Ref 1: Proposal No. IA/KL/MIN/232178/2021

Ref 2: As per minutes of 16th EAC (Non-Coal Mining) meeting held on 20th June, 2023

Sub: ADS submission of environmental clearance application for Granite Building Stone Quarry of M/s Morayoor Granites Private Limited, for an extent of 4.9797Ha.

INDEX

Figure 2: Construction of Desiltation tank from surface drainage plate

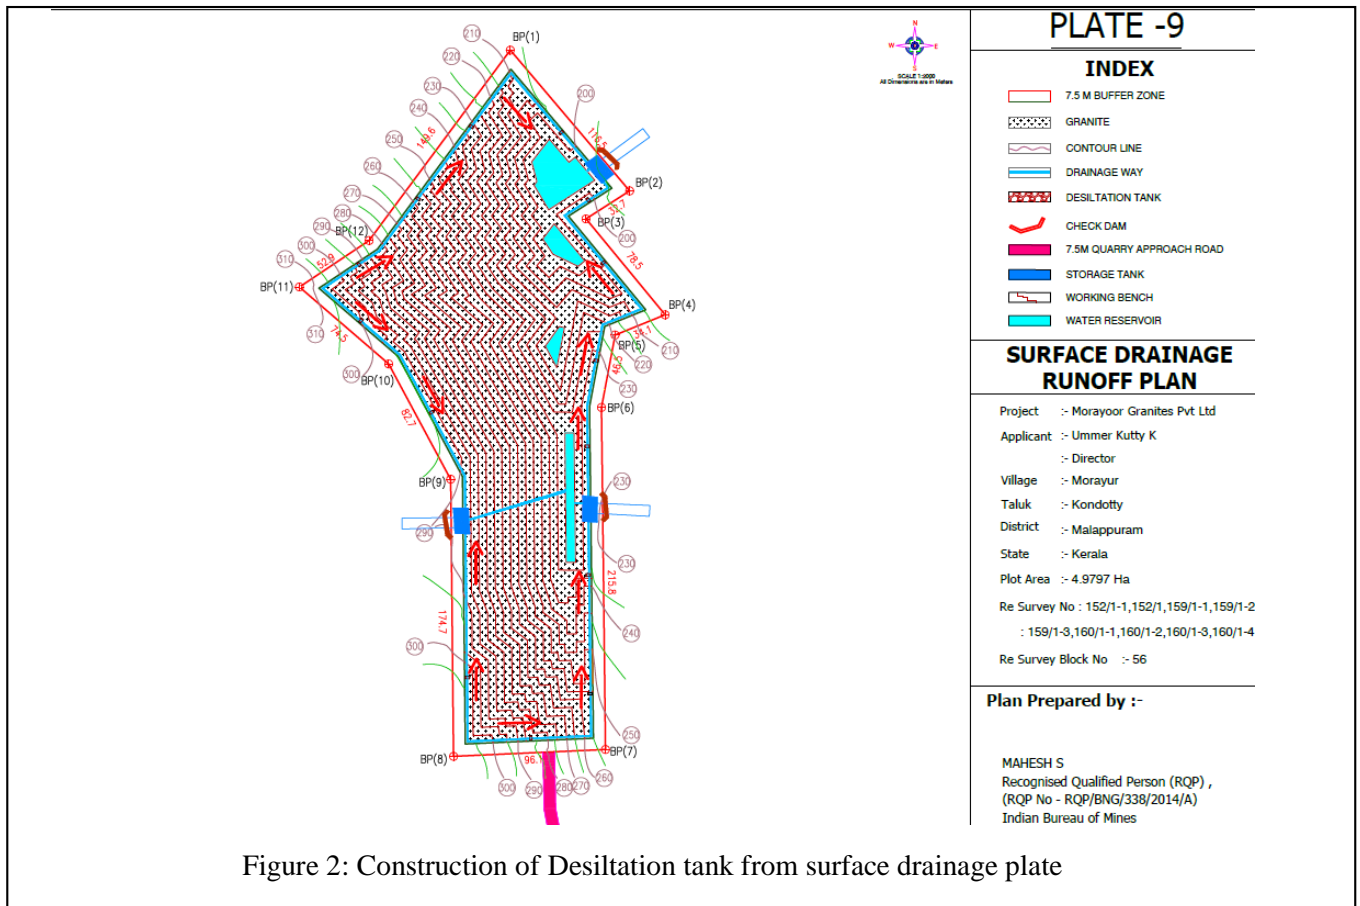
3. The PP shall construct Garland drains around the mining pits to channelize surface water from higher elevation areas to nearby areas within mining lease. The Garland drains will have silt check dams at regular interval. Finally, the Garland drains will be terminated into settling ponds where the sediments will get settled and rain water should be harvested by construction of rain water harvesting pond/tank. Retaining walls will be erected around the temporary waste dumps, which will eventually be backfilled into the mined out pits

- ✓ A garland drainage will be constructed at the start of mining itself.
- ✓ In the initial phase, garland drainage with silt traps will be constructed along the boundary pillars BP8-BP10-BP11-BP12.

- ✓ While mine progressing stage, garland drain will be constructed along the boundary pillars BP8-BP7-BP6-BP5-BP4.
- ✓ We will construct the garland drain of above mentioned area.

- ✓ In the second year, Garland Drainage with silt traps constructed in the northern stretch of the lease area i.e, along the boundary pillars BP2-BP1.

- ✓ Garland Drains will be constructed in the lower slope of Project area about having dimensions of 1m width around the working benches
- ✓ The surface runoff water from the quarry area carries by Garland Drains and flows through silt traps at each slope breaks.

- ✓ Collected run-off from the lease area passes through De siltation tanks.
Two De siltation tanks will be proposed in the quarry area.
- ✓ One De siltation tank will be proposed nearer to the boundary pillars BP6 having dimensions of 3mx1.5mx2.5m and another one proposed nearer to boundary pillar BP2 of lease area having dimensions of 3mx1.5mx2.5m.

- ✓ We will construct the De siltation tanks. Clarified and controlled water flow passes through check dam.
- ✓ From the check dam, the controlled flow only connects to the existing natural Drainage

Google image showing 200m study area

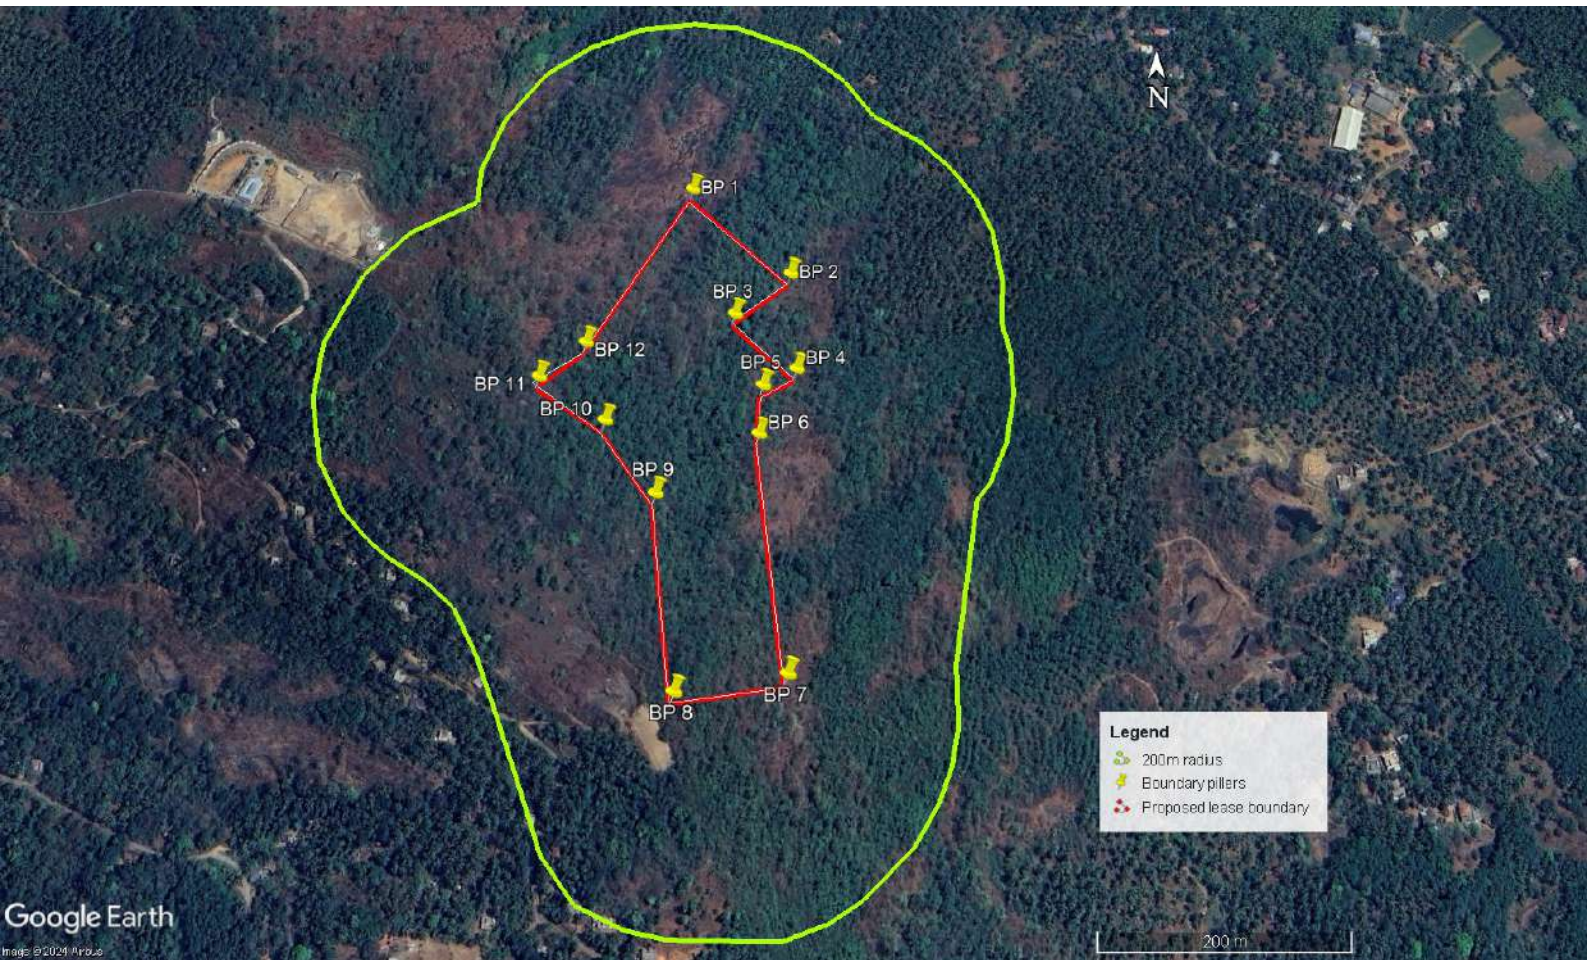
5. During site visit, no habitation seen within a vicinity of 200 meters and the same has been reiterated through google earth image.

There is no habitation is occurring in 200m area, hence we are attaching google earth image of 200m area as Annexure 04 and also we are attaching the survey map of the same as Annexure 05
